SUBJECT: SURRY POWER STATION, UNIT NOS. 1 AND 2 - STAFF ASSESSMENT OF INFORMATION PROVIDED PURSUANT TO TITLE 10 OF THE *CODE OF FEDERAL REGULATIONS* PART 50, SECTION 50.54(f), SEISMIC HAZARD REEVALUATIONS FOR RECOMMENDATION 2.1 OF THE NEAR-TERM TASK FORCE (NTTF) REVIEW OF INSIGHTS FROM THE FUKUSHIMA DAI-ICHI ACCIDENT AND STAFF CLOSURE OF ACTIVITIES ASSOCIATED WITH NTTF RECOMMENDATION 2.1, "SEISMIC" (TAC NOS. MF3953 AND MF3954)

STAFF ASSESSMENT BY THE OFFICE OF NUCLEAR REACTOR REGULATION

RELATED TO SEISMIC HAZARD AND SCREENING REPORT

SURRY POWER STATION, UNITS 1 AND 2

Figure 3.3-1: Plot of Staff's and Licensee's Base Case Shear-Wave Velocity Profiles for the SPS site

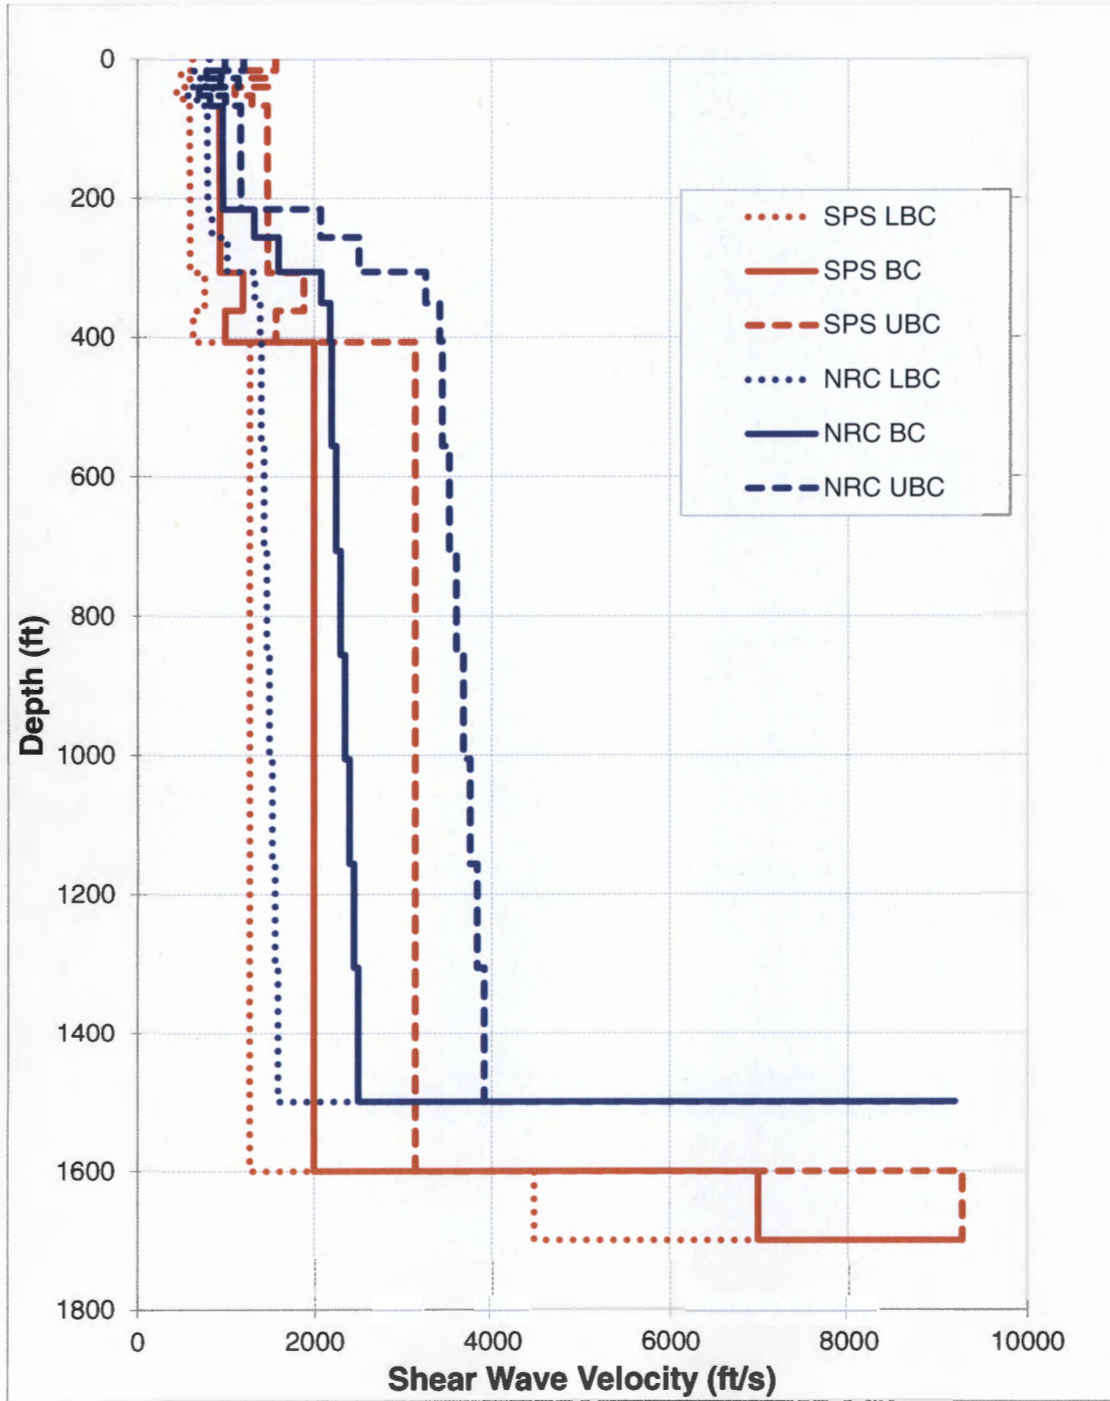
To estimate the shear wave velocities for its best estimate or middle base case profile for the upper 140 ft. [42.7 m], the licensee used the blow count values from Standard Penetration Testing. For the deeper soil layers to a depth of 1600 ft. [488 m], the licensee estimated the shear wave velocities based on the soil type and its depth beneath the site. Finally, for the metamorphic rock between 1600 ft. [488 m] and 1700 ft. [518 m], the licensee assumed a shear wave velocity of 7000 feet per second (fps) [2130 meters per second (m/s)]. At a depth of 1700 ft. [518 m], the licensee assumed the reference or base rock shear wave velocity of 9200 fps [2800 m/s]. Due to the large uncertainty in the shear wave velocity estimates for the best estimate base case profile, the licensee calculated lower and upper base case profiles using a scale factor of 1.57, reflecting a natural log standard deviation of 0.35. Table 2.3.1-2 and Figure 2.3.2-1 of the SHSR provide the licensee's shear-wave velocity profile for each of the three

base cases. Figure 3.3-1 of this assessment shows the licensee's three shear-wave velocity base case profiles.

To develop its best estimate base case velocity profile over the upper 200 ft. [61 m], the NRC staff assumed the same values as the licensee. Below 200 ft. [61 m], the NRC staff assumed a constant velocity gradient down to the base of the profile at a depth of 1,500 ft (457 m). To capture the uncertainty in the shear wave velocities, the NRC staff used a scale factor of 1.21 to calculate upper and lower base case velocity profiles, which is consistent with a natural log standard deviation of 0.15. Figure 3.3-1 of this assessment shows a comparison of the three velocity profiles developed by the licensee with those developed by the NRC staff. The profiles developed by the NRC staff are similar to those developed by the licensee, but have higher velocities at depths greater than 200 ft (61 m). In addition, the NRC staff assumed a somewhat shallower depth to metamorphic rock beneath the site and that the shear wave velocity for this rock is the reference rock value of 9200 fps (2800 m/s). The NRC staff randomized the depth to reference rock by  $\pm 300$  ft (91 m) to allow for additional uncertainty.

Figure 3.3-2 Plot Comparing the Staff's and the License's Median Amplification Functions and Uncertainties for two input loading levels for the SPS site

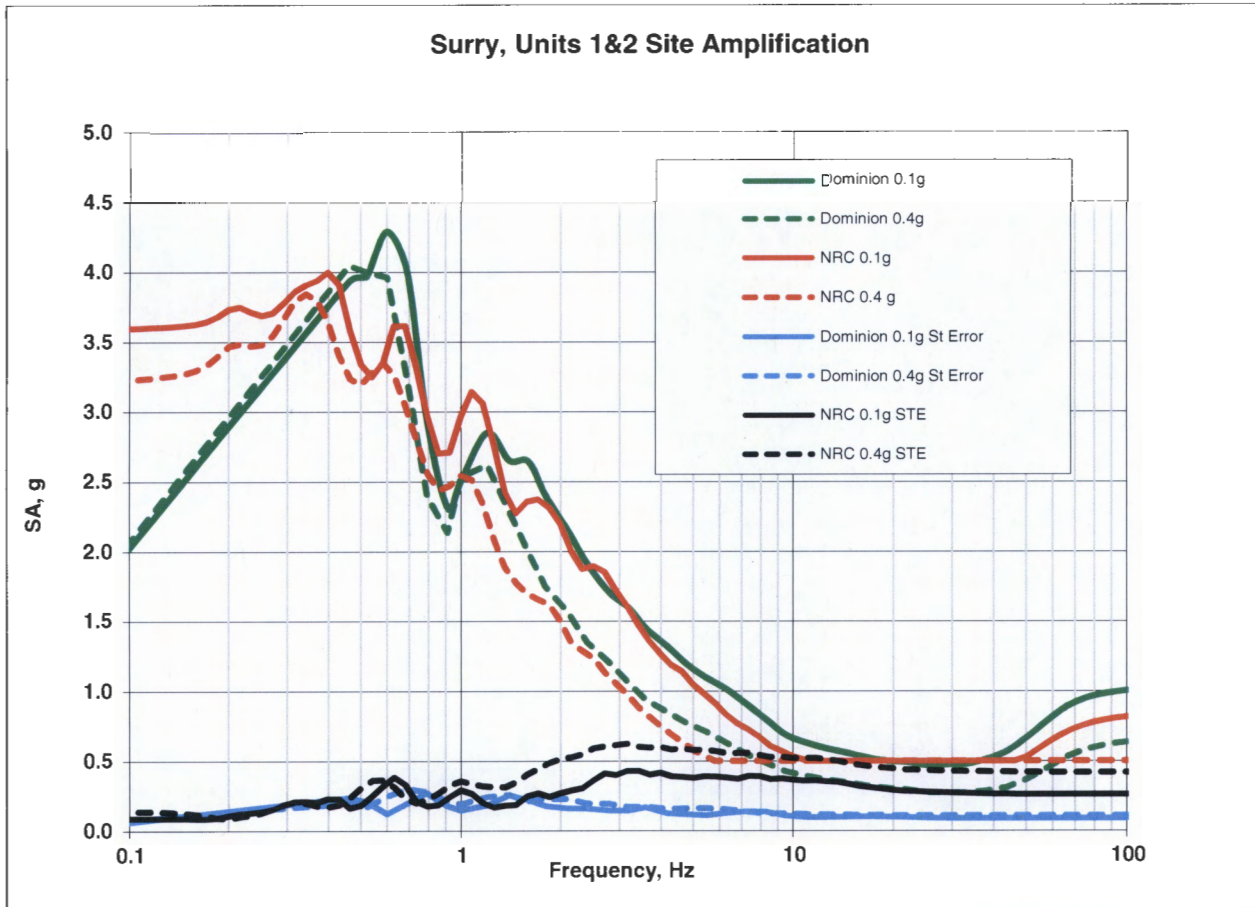
Figure 3.3-2 of this assessment shows a comparison of the staff's and licensee's median site amplification factors and uncertainties ( $\pm 1$  standard deviation) for 2 of the 11 input loading levels. The staff's median site amplification factors are similar to the licensee's amplification factors. In addition, the staff's and licensee's uncertainties are similar at frequencies below 2 Hz. At higher frequencies the staff's uncertainties are slightly higher than the licensee's.

Figure 3.3-3 Plot Comparing the Staff's and the Licensee's Mean Control Point Hazard Curves at a Variety of Frequencies for the SPS site

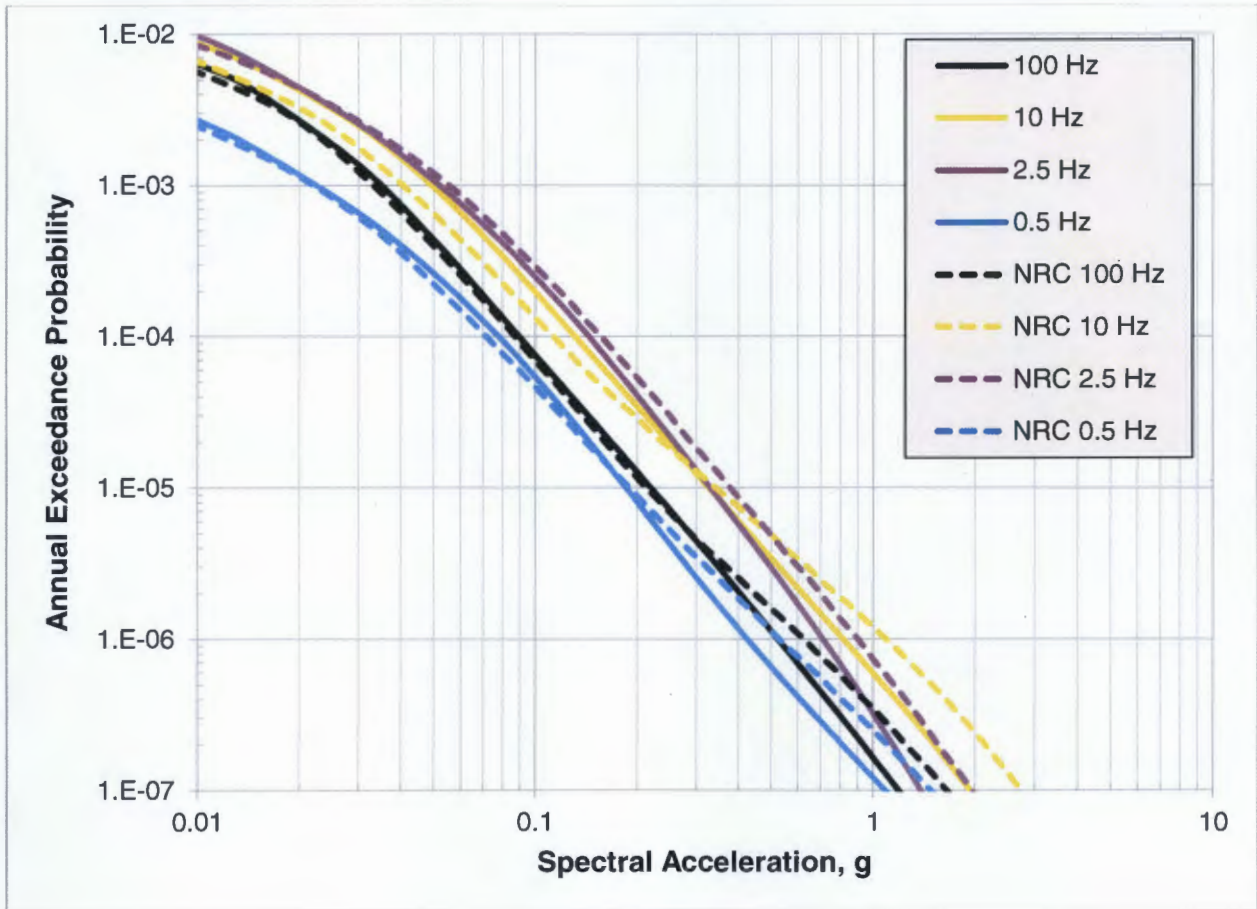
The licensee's approach to modeling the subsurface rock properties and their uncertainty results in similar site amplification factors. As shown in Figure 3.3-3, the control point seismic hazard curves developed by the licensee and NRC staff are also similar. Appendix B of the SPID provides guidance for performing site response analyses, including capturing the uncertainty for sites with less subsurface data. As such, alternative approaches in performing site response analyses, including the modeling of uncertainty, are acceptable for the 50.54(f) response.

Figure 3.4-1 Comparison of the Staff's GMRS, Licensee's GMRS, and the SSE for the SPS site

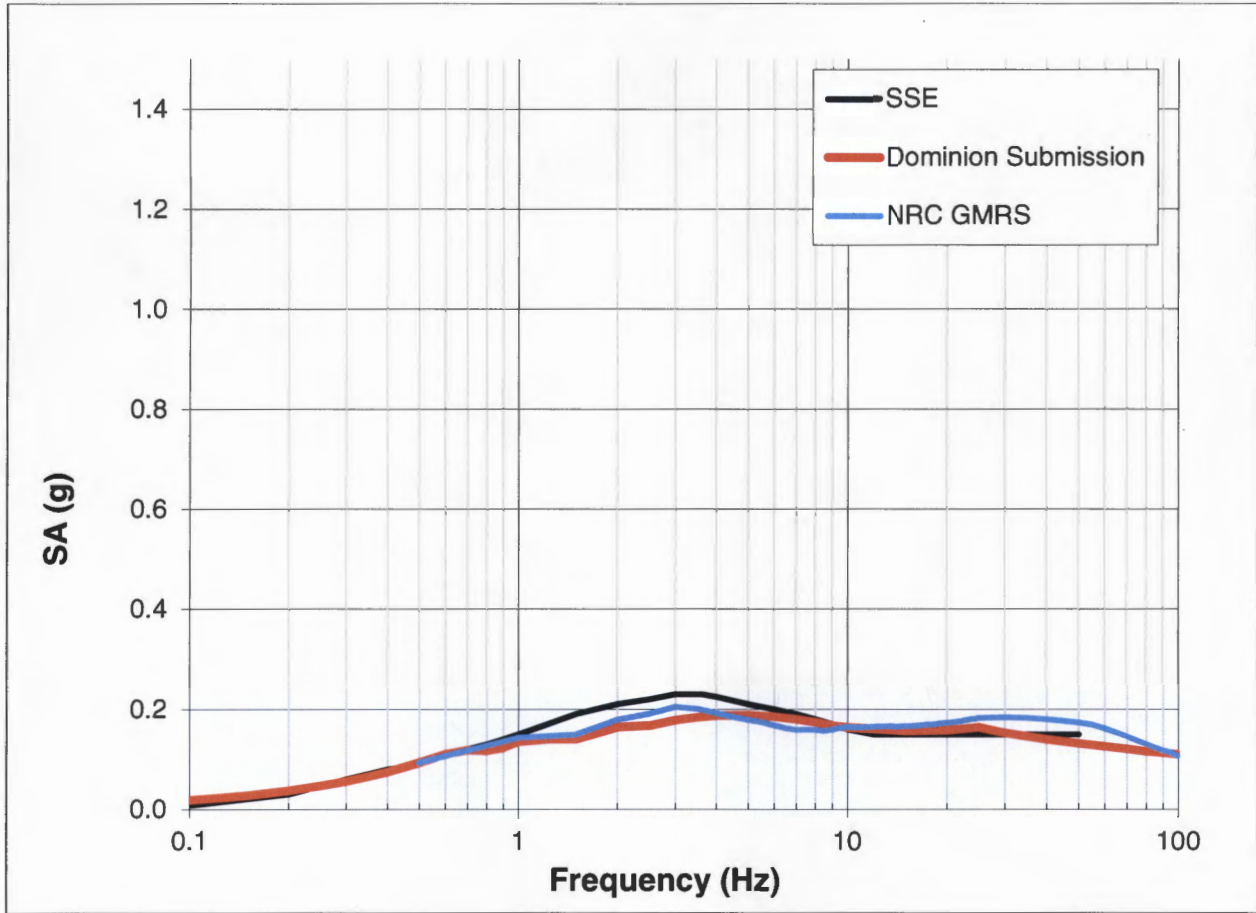
The NRC staff independently calculated the  $10^{-4}$  and  $10^{-5}$  UHRS using the results of its confirmatory PSHA and site response analyses, as described in Sections 3.2 and 3.3 of this staff assessment, respectively. Figure 3.4-1 of this assessment shows a comparison of the GMRS determined by the licensee to that determined by the NRC staff.

As shown in Figure 3.4-1 below, the licensee's GMRS shape is similar to that calculated by the NRC staff at frequencies less than 10 Hz. However, the staff's confirmatory GMRS is somewhat higher than the licensee's at frequencies above 10 Hz. As described above in Section 3.3, the NRC staff concludes that these minor differences over the higher frequency range are primarily due to the differences in the site response analyses performed by the licensee and NRC staff.

In reaching this determination, the NRC staff confirmed the licensee's conclusion that the licensee's GMRS for the Surry site is bounded by the SSE in the 1 to 10 Hz range. A comparison of the SSE with GMRS shows overlap in the 9 – 10 Hz range. As such, the NRC staff determined that a seismic risk evaluation and SFP evaluation (i.e., Requested Information Items (8) and (9)) are not necessary for Surry. Further, the NRC staff also concluded that the GMRS and SSE overlap at frequencies greater than 10 Hz, and as such, the NRC staff determined that a HF confirmation (i.e., Requested Information Item (4)) is not merited. Based upon the preceding analysis, the NRC staff concludes that the licensee responded appropriately and has completed its response to Enclosure 1, of the 50.54(f) letter.
